Minutes of Meeting Pre –bid meeting held in the Conference Hall of KINFRA Hi Tech Park and via Google Meet on 25.10.2021 at 02:30 PM.

Name of work: Development of KINFRA Petrochemical Park at Ambalamughal, Kochi, Kerala – Phase I works

The queries and reply are attached as follows.

TITLE	TYPE
SCHEMATIC DIAGRAM ADMIN BLOCK	ELECTRICAL SERVICE
	DRAWING NUMBER
	ADM SCH 002

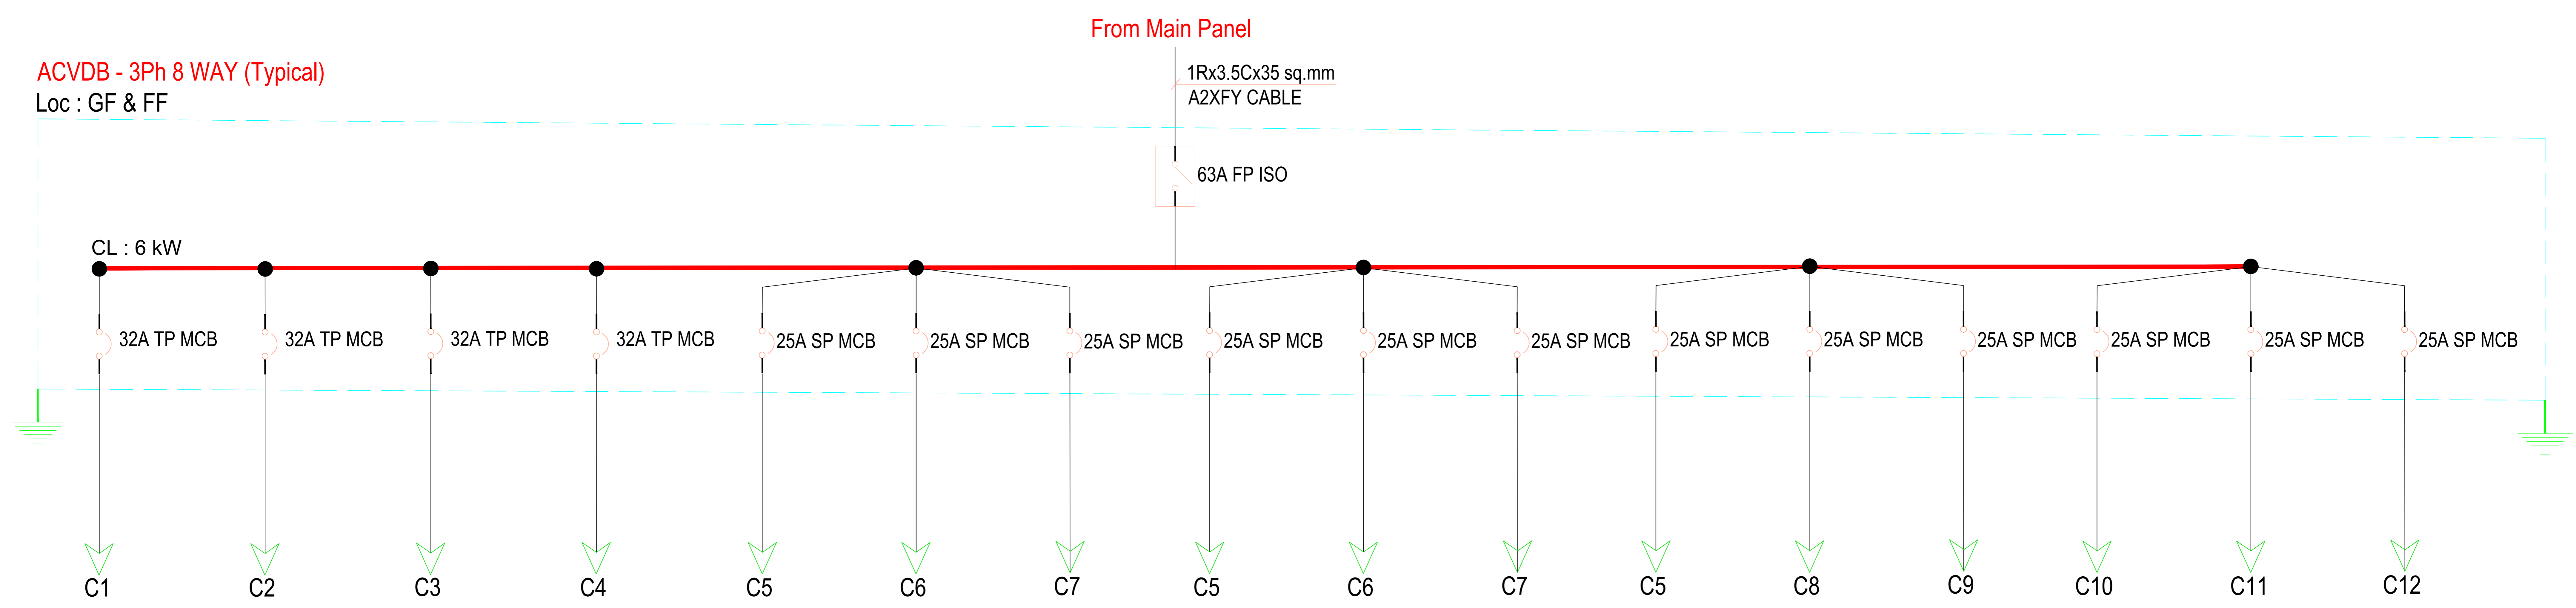
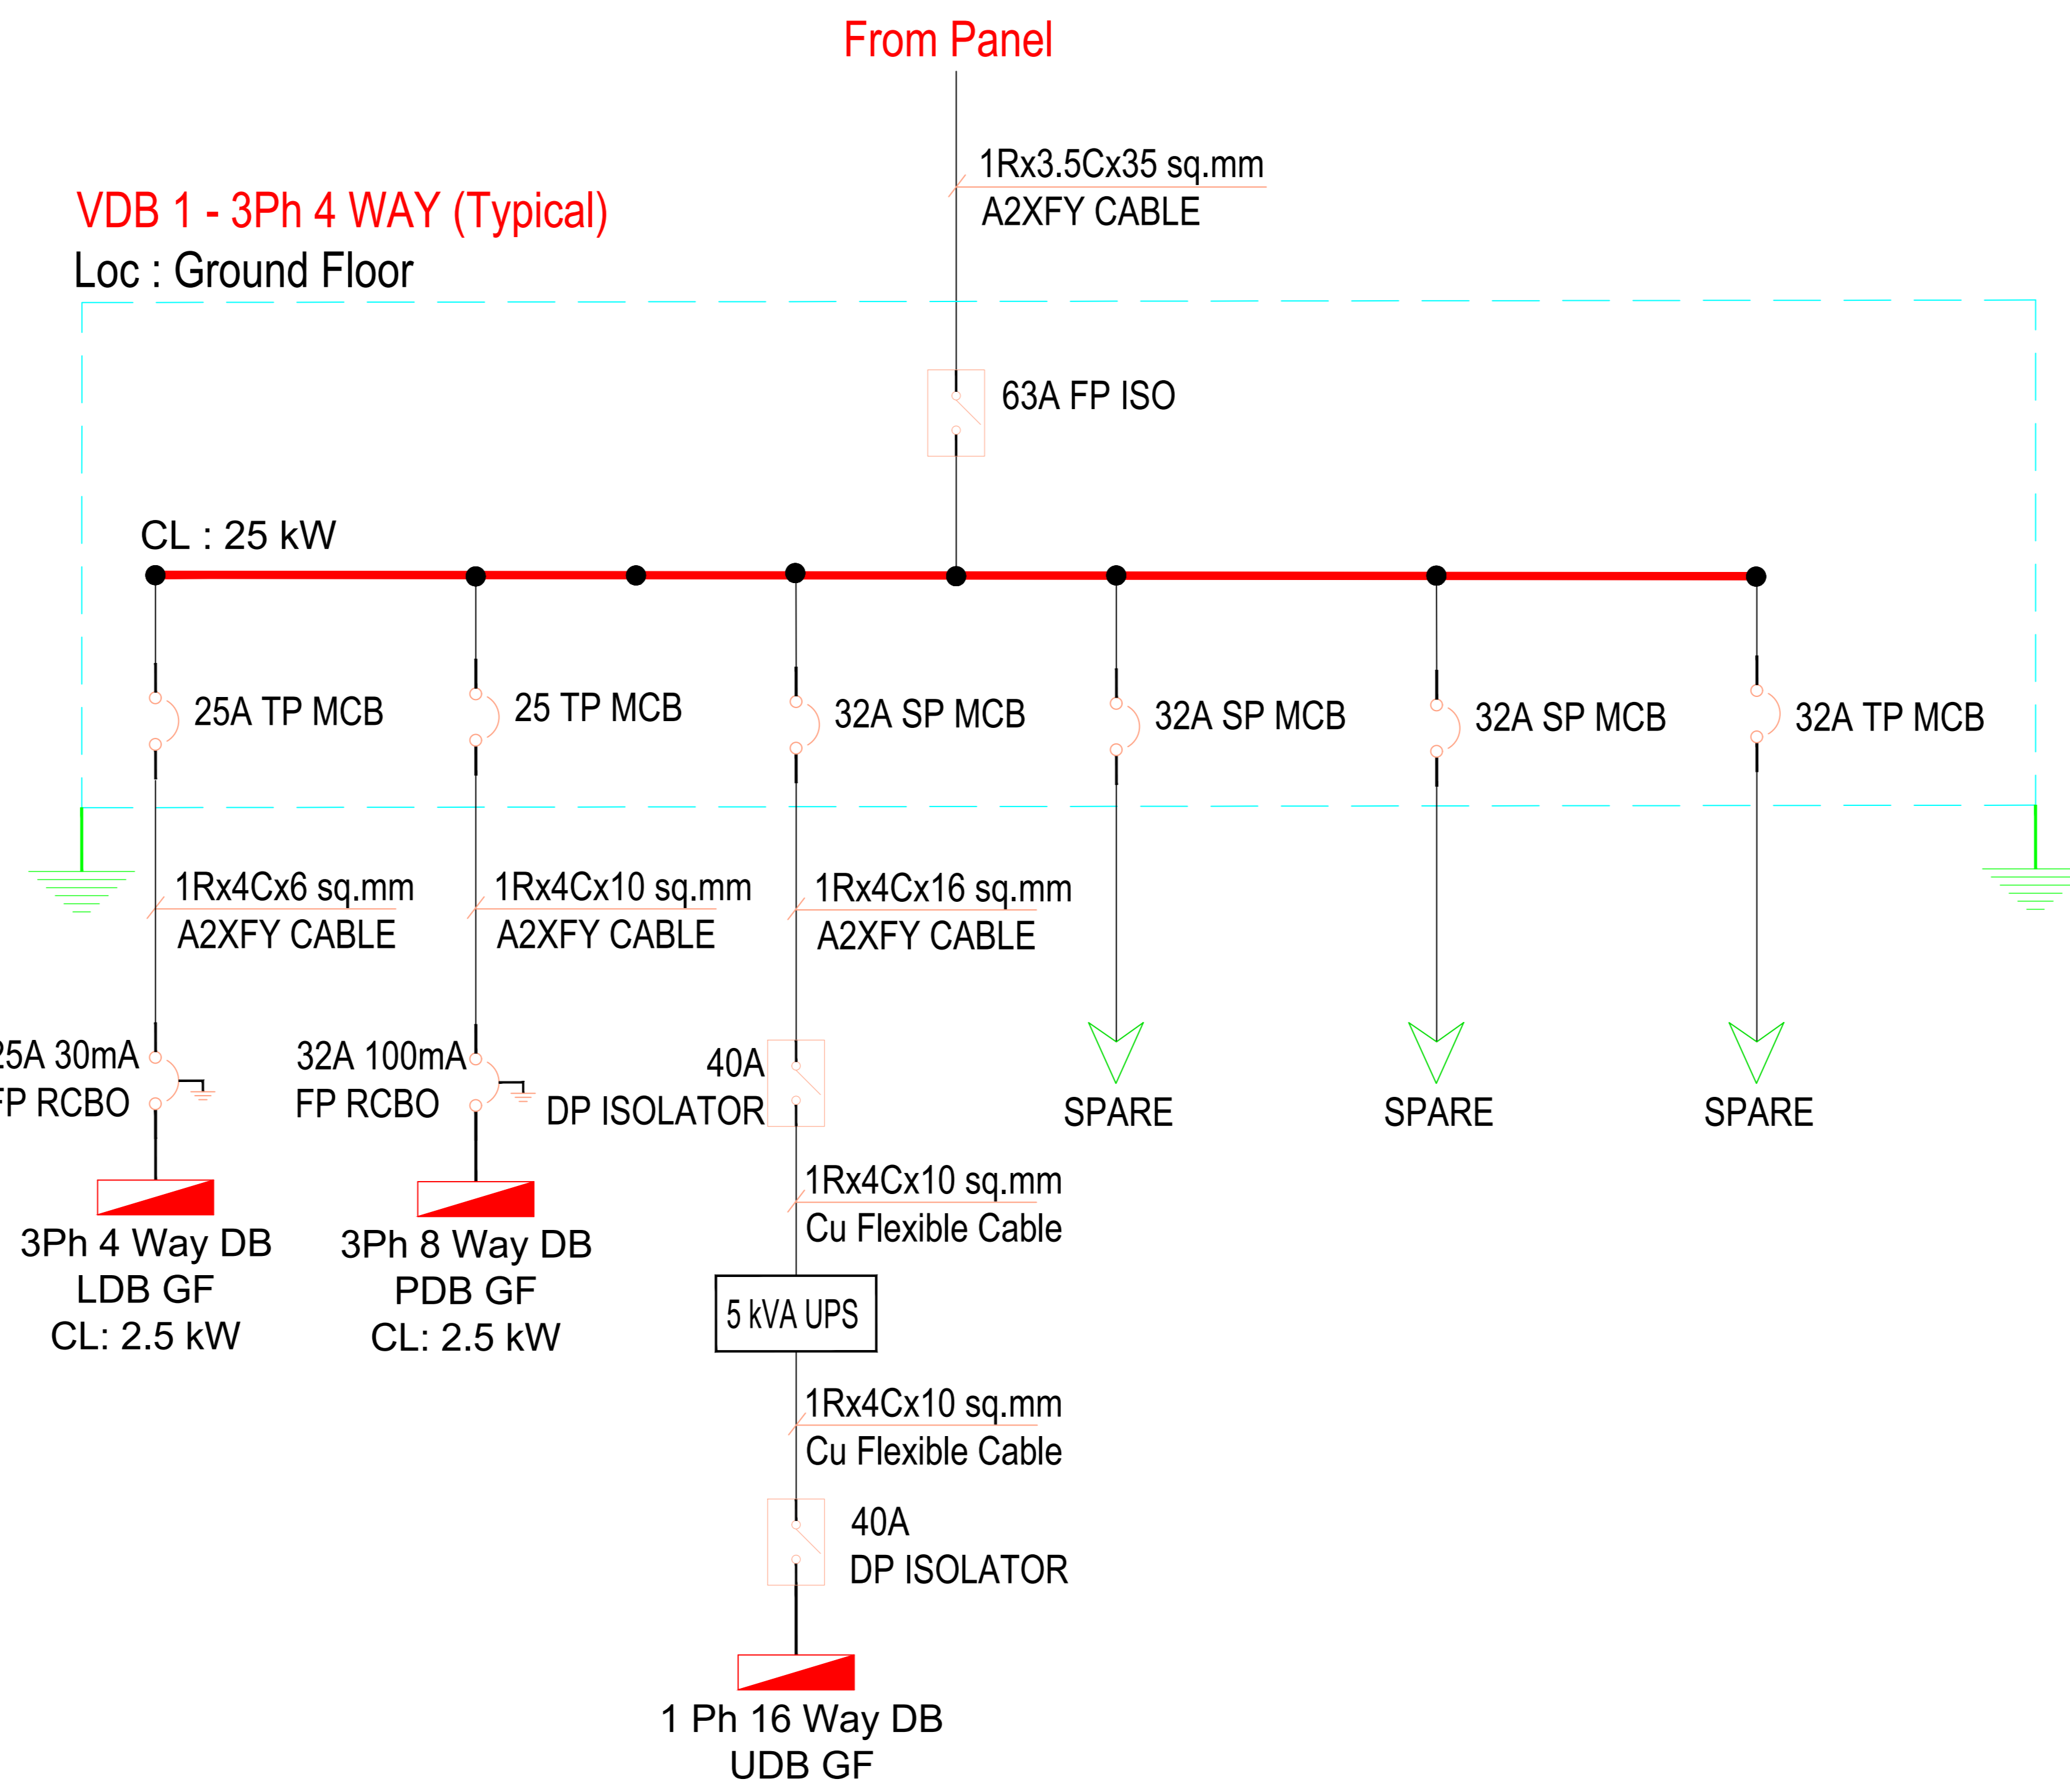
71		Technical specification of Compact Substation	Attached as annexure
72		The report on soil investigation and CBR surveys	Attached as annexure
73		Any Revised Drawings	The revised drawings of electrification in Admin Building is attached as annexure

Revised Drawings of Electrification in Admin Building
